Subject: Dare County C&D Landfill
Dare County, North Carolina
Substantial Amendment and Phase V Permit to Construct Application
Revision Request

Attachment A
Stockpile Triaxial Test Results

Attachment B

**CONSOLIDATED UNDRAINED TRIAXIAL TEST
WITH PORE PRESSURE READINGS
ASTM D4767-11**

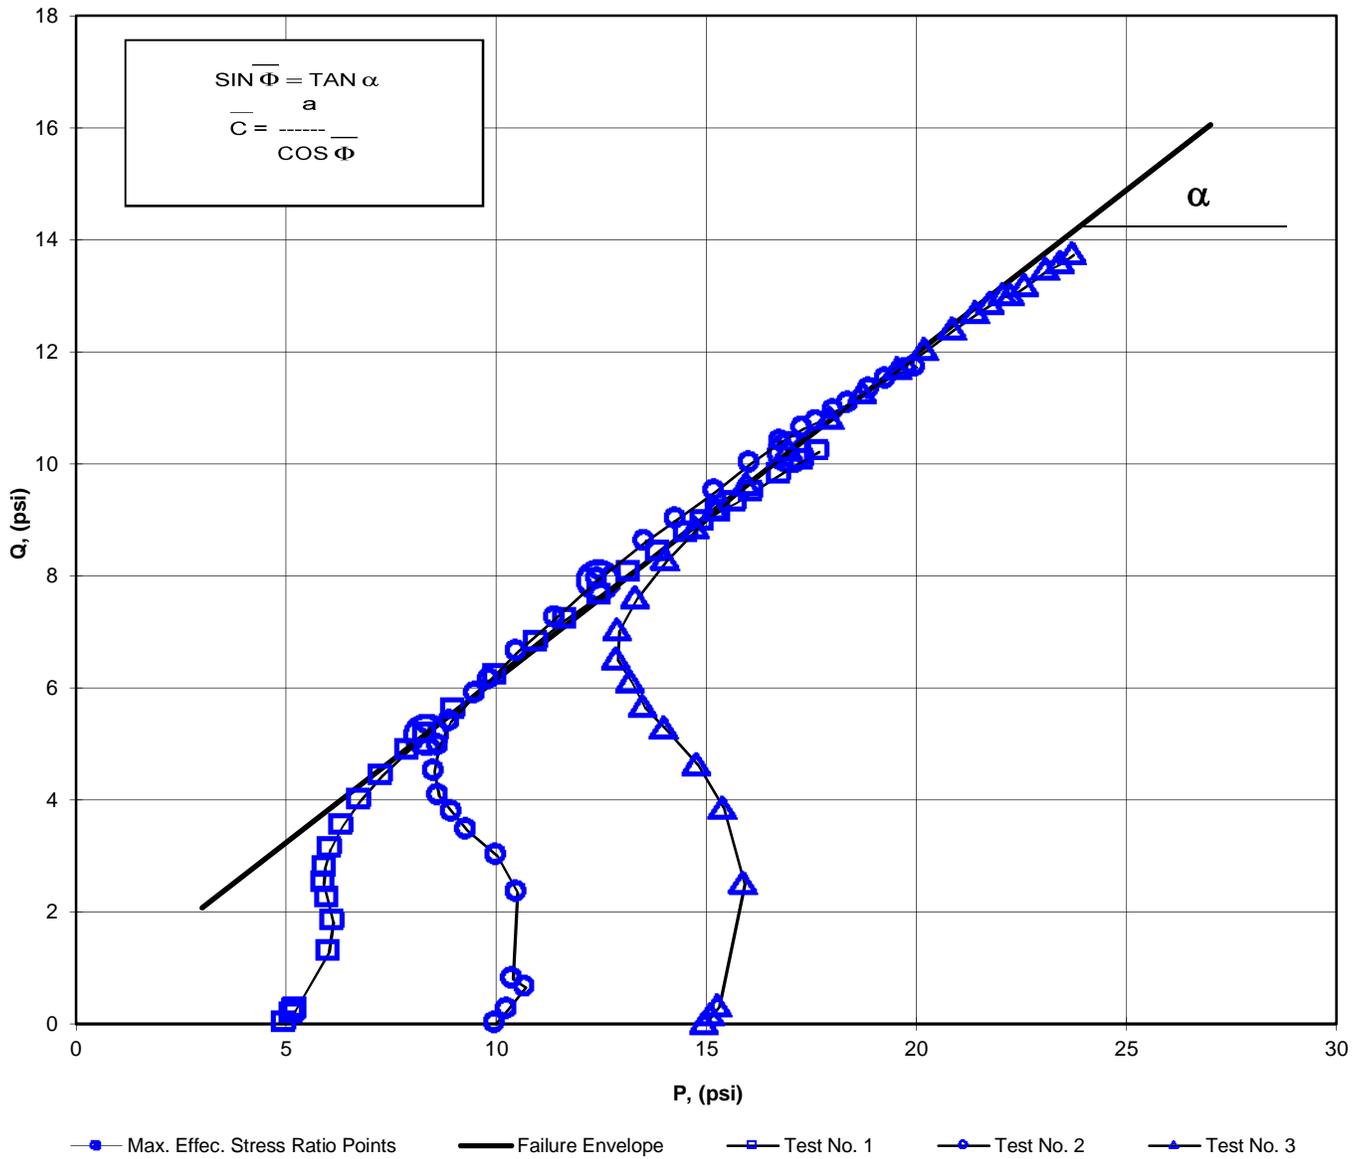
In addition to several other parameters, the geotechnical samples were analyzed for internal friction angle via triaxial tests (ASTM D4767). One sample demonstrated an internal friction angle of 35.60 degrees, but the other was measured at 29.46 degrees. Copies of the triaxial test results for the 2 samples are provided in **Attachment A**. Based on the test result, a CDM Smith geotechnical engineer reviewed the geotechnical evaluation and determined that a revised minimum internal friction angle of 28 degrees would still be sufficient to meet the factor of safety used for landfill design, without revision. Copies of the global stability analysis scenarios are provided in **Attachment B**.

a	=	0.00	\overline{C}	=	0.00
α	=	30.2	$\overline{\Phi}$	=	35.60

In order to utilize the onsite soils and to limit the likelihood of having to remove and replace a failing test area during base pad construction, CDM Smith would like to revise the construction materials conformance requirements from an internal friction angle of 30 degrees to 28 degrees. As stated above, revision of the angle should alleviate the potential issue of deficient onsite materials and it will not have an impact on the geotechnical design of the landfill.

**CONSOLIDATED UNDRAINED TRIAXIAL TEST
WITH PORE PRESSURE READINGS
ASTM D4767-11**

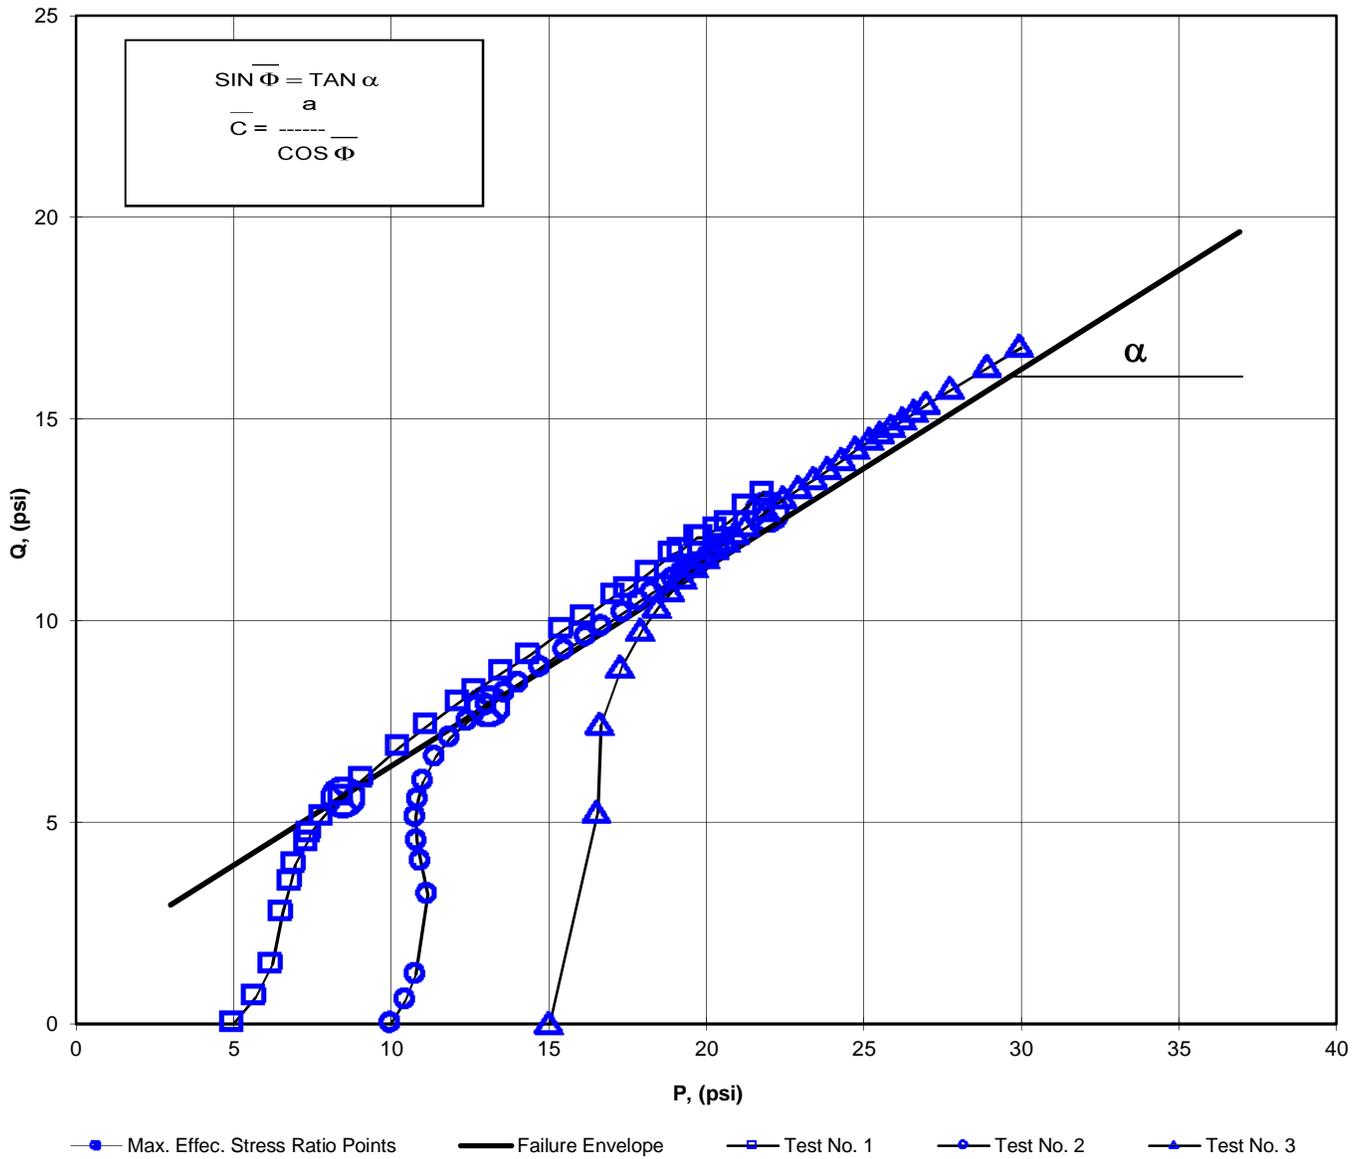
a	=	0.00	\overline{C}	=	0.00
α	=	26.2	$\overline{\Phi}$	=	29.46
